Construction Division
Additions & Alteration Charges Approval Form

Company Name:	MRMLLP	Site	Gulmohar Residency
Name of the customer	Mohith Narang		
Villa/ Flat No.	D-603

Quality Control Check Report. Stage: After Finishing Stage II (Apartments)

Details of Additions & Alterations

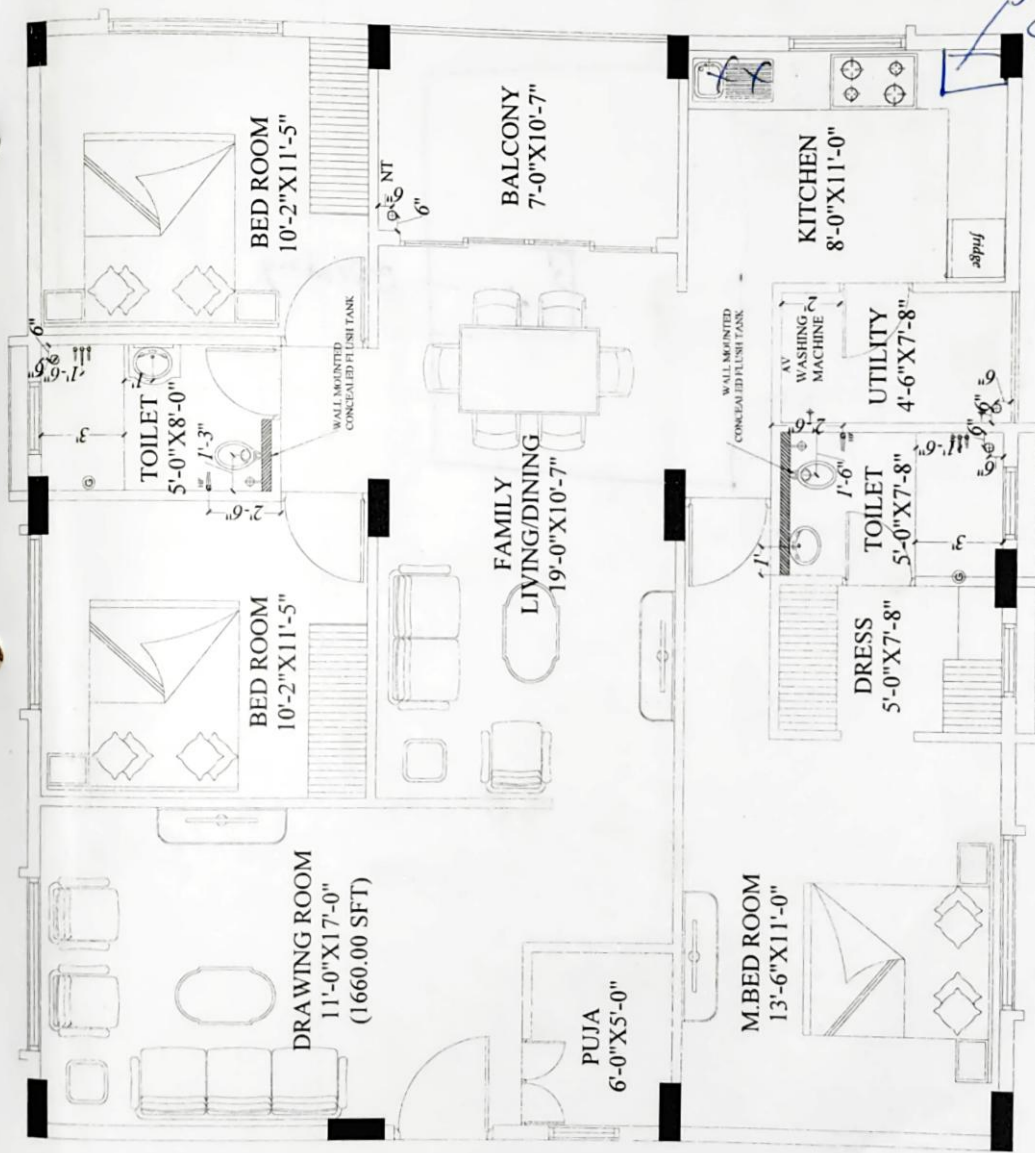
SS Sink

Description	Direction	Owners & Developers :	Date :	Promoted by
			23.09.2020	
			Prepared By : Jayapradha	
			Approved By : Soham Modi	
ELECTRICAL PLAN -B2 TYPE-1660 sq ft	N	Project Name & Phase : Gulmohar Residency	Scale :	Phone:+91-40-66335551

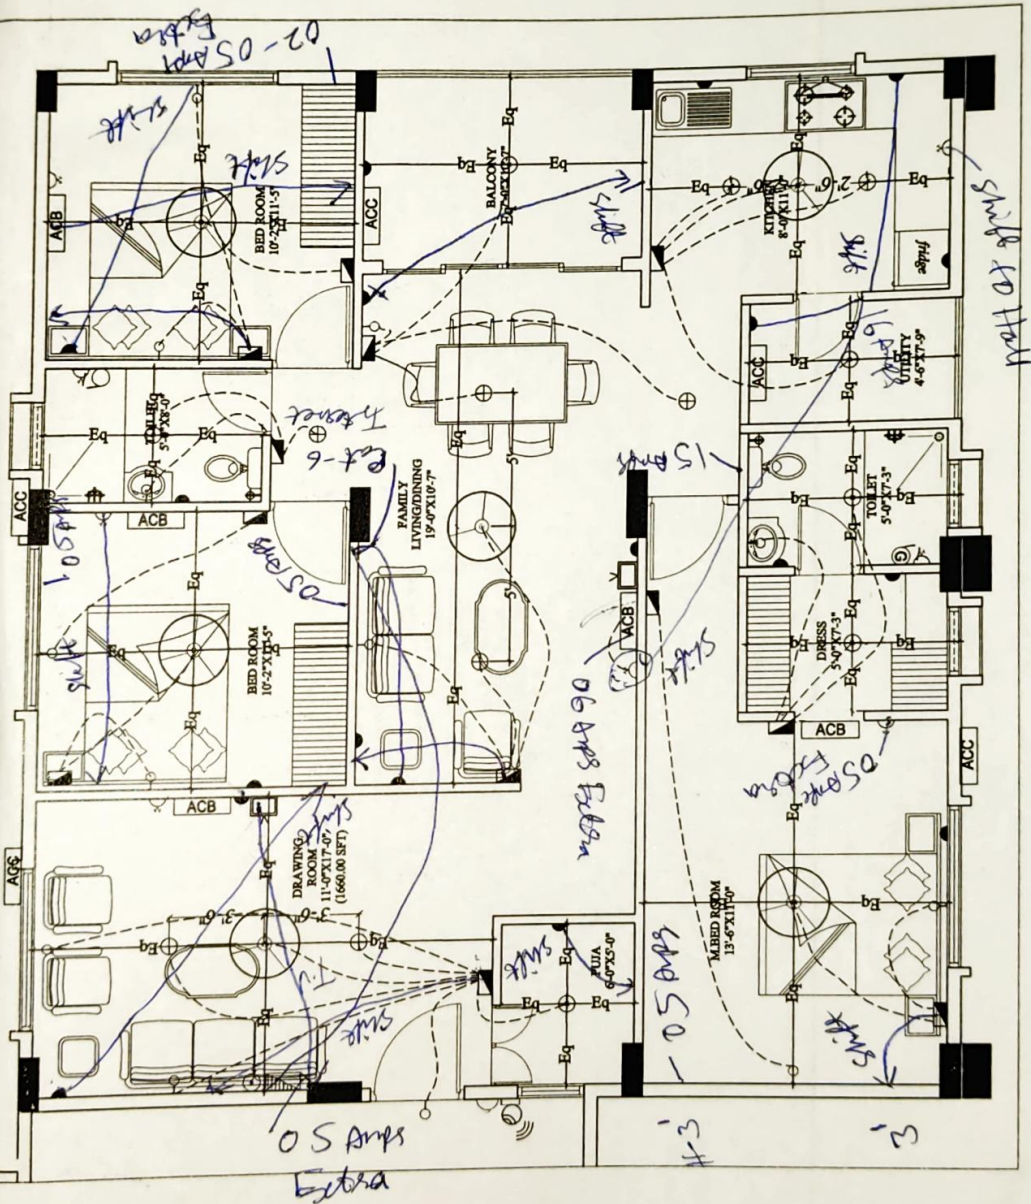
Changes in electrical points: (mark on plan)
